Consideration of Comments for SAR for Permanent Changes to the Timing Tables in the Coordinate Interchange Standards

The SAR requester working on the Permanent Changes in the timing tables used in Coordinate Interchange standards INT-005, INT-006, and INT-008 thanks all commenters who submitted comments on Draft 1 of the SAR. This SAR was posted for a 30-day public comment period from April 20 through May 21, 2007. The requester asked stakeholders to provide feedback on the SAR through a special SAR Comment Form. There were 8 sets of comments, including comments from 32 different people from 20 companies representing 6 of the 10 Industry Segments as shown in the table on the following pages.

Attachment 1 - Proposed Timing Table from JISWG

Timing Requirements for all Interconnections except WECC

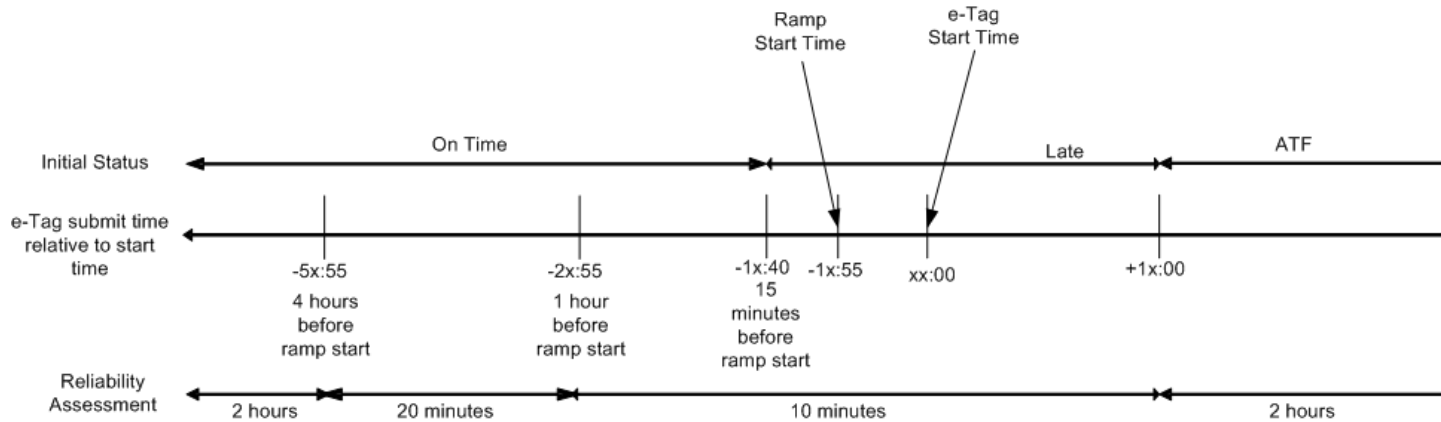
Question #3			
Commenter	Yes	No	Comment
JISWG		<input checked="" type="checkbox"/>	For this question, please see the attached table. Changes were made to the table at the May 16, 2007 JISWG meeting. The same changes are being submitted to NAESB under Request R07007. JISWG believes the changes made to the table provide clarity for timing requirements. While the majority of changes are formatting in nature, therefore leaving the intent as is, these formatting changes provide a better understanding of the timing requirements.

Question #5			
Commenter	Yes	No	Comment
JISWG		<input checked="" type="checkbox"/>	Attached table has a replacement row that is <1 hour and >10 minutes prior to ramp start.
Response: The requester agrees with the JISWG changes.			
IESO	<input checked="" type="checkbox"/>	<input checked="" type="checkbox"/>	See comments on Q3.
Response: Please see the response to your comments on Q3.			
AEP	<input checked="" type="checkbox"/>		
IRC SRC	<input checked="" type="checkbox"/>		
Manitoba Hydro	<input checked="" type="checkbox"/>		
PSC South Carolina	<input checked="" type="checkbox"/>		
So. Co. Transmission	<input checked="" type="checkbox"/>		
Xcel Energy	<input checked="" type="checkbox"/>

Response: The proposed changes from JISWG provide additional clarity to the tables. The SAR will utilize these tables.			
Xcel Energy		<input checked="" type="checkbox"/>	Looking at the NERC website under the JISWG, I reviewed the most recent version 1.7 and the second draft of version 1.8. Both of these documents had three definitions related to the submission time, On Time, Late and After The Fact. The proposed timing table should be limited to these three designations. The Pre-Late designation has no reliability reason for existence. If the WECC wishes to have a cut-off time for prescheduling purposes, set a time and do not include tags submitted after that time in the preschedule checkout. In fact, based upon the Western Interchange Tool, the increased automation of scheduling packages in general, and the E-tagging process, Xcel Energy does not see any value in continuing the historical practice of a preschedule checkout. If the WECC does feel a need to continue this practice, there is no need to assume that a tag should be denied due to missing an artificially imposed deadline for a checkout. Denials of these tags only causes duplication of effort later which is inefficient and time consuming for all parties for no reliability benefit.

Summary Consideration: Most commenters agreed with the proposed modification – the NERC/NAESB Joint Interchange Scheduling Working Group (JISWG) that initiated the modifications to the timing table provided a new update for this row and instead of the proposed language, the revised SAR adopts the language proposed by the JISWG: RFI submitted <1 hour and >10 minutes prior to ramp start. The latest version of the proposed timing table has been attached to this document and is included in the revised SAR.

Timing Requirements for WECC

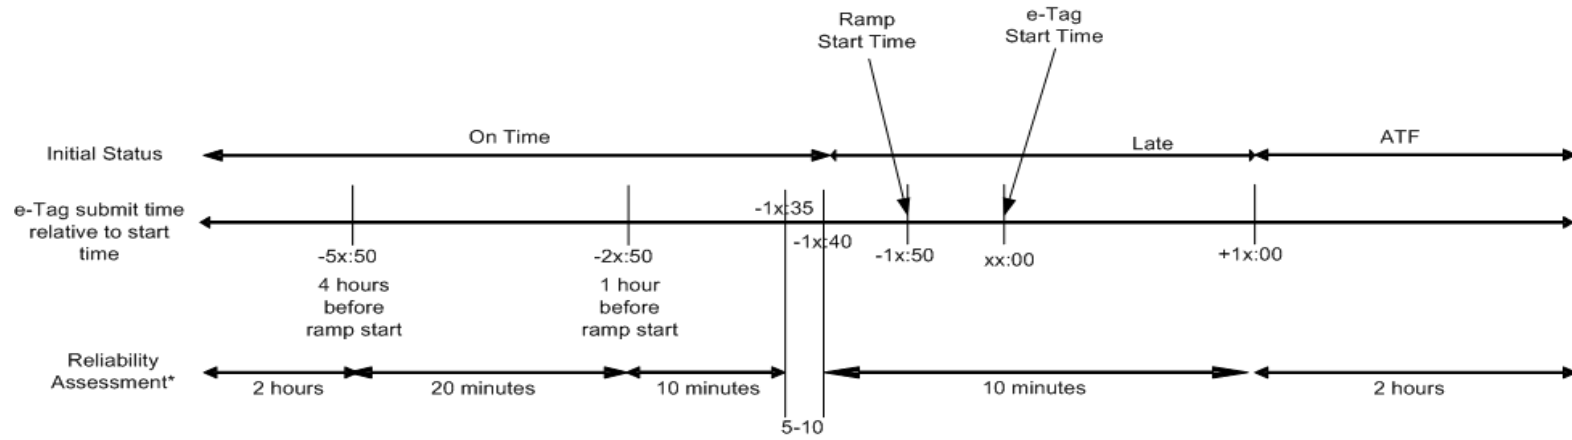
Question #6			
Commenter	Yes	No	Comment
JISWG		<input checked="" type="checkbox"/>	JISWG eliminated this row in their reformatted timing requirement tables. In its place, JISWG created a new row to focus on pre-scheduled tags for the WECC.
Response: The requester agrees with JISWG changes.			
Xcel Energy		<input checked="" type="checkbox"/>	There is no definition available to review that I have seen. Without a definition, it is impossible to support this designation.
Response: This row was removed from the revised SAR.			
IESO	<input checked="" type="checkbox"/>	<input checked="" type="checkbox"/>	See comments on Q3.
Response: Please see the response to your comments on Q3.			
AEP	<input checked="" type="checkbox"/>		
IRC SRC	<input checked="" type="checkbox"/>		
Manitoba Hydro	<input checked="" type="checkbox"/>		
PSC South Carolina	<input checked="" type="checkbox"/>

Summary Consideration: The NERC/NAESB Joint Interchange Scheduling Working Group (JISWG) that initiated the modifications to the timing table provided a new update to the timing table and this row is no longer included. The latest version of the proposed timing table has been attached to this document and is included in the revised SAR.
